Siemens Technical Bulletin STAB16-0101

Issue with recent batch of ST900/950ELV HPU boards

20th July 2016

Product: ST900/950ELV
Modifications Req: No
Retrospective Action Req: Yes
Priority of Change: Urgent ASAP

Figure1: HPU board with 12V Relays fitted (shown as -12DE)

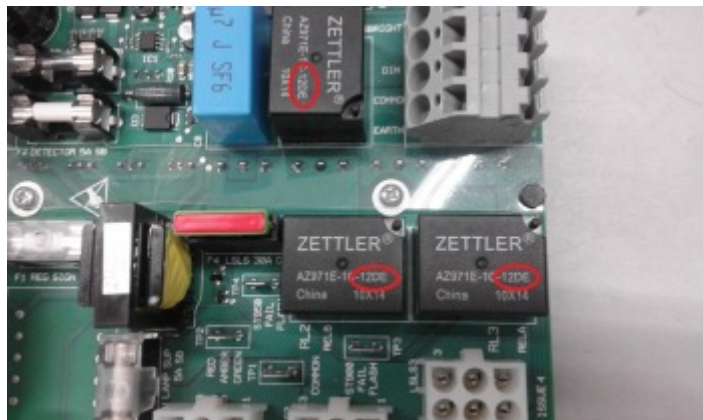
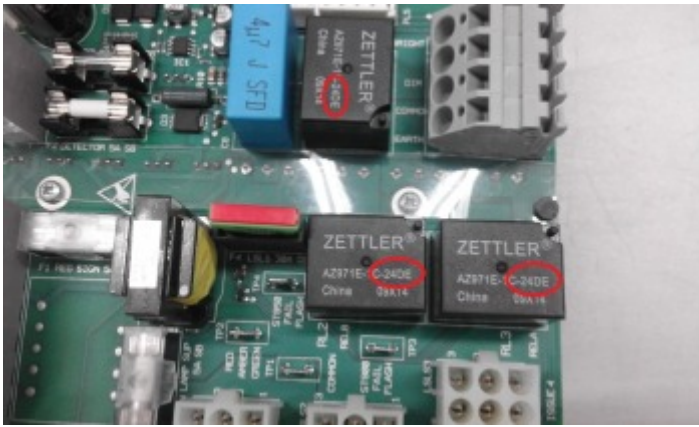
It has recently been found that there was a batch of ST900/950ELV HPU boards fitted with the wrong relays. The result of this error means that these HPU boards will eventually cause the CPUs boards to fail (FLF17) and in some cases this may cause heat damage to the pcb.

The HPU boards in question were built in early March and have 12V Relays fitted instead of 24V Relays. The figures below show how to identify the Relays on the HPU board.

For any ST900/950ELV controllers commissioned in the last month and any that are being installed/commissioned in the next 3months, it is recommended to check the HPU board to ensure that it is fitted with 24V Relays. The longer the units with this error are left powered the more likely the HPU and CPU boards are to suffer non repairable damage.

Any HPUs (including those issued as spares) found with 12v Relays should be returned immediately to Poole for modification.
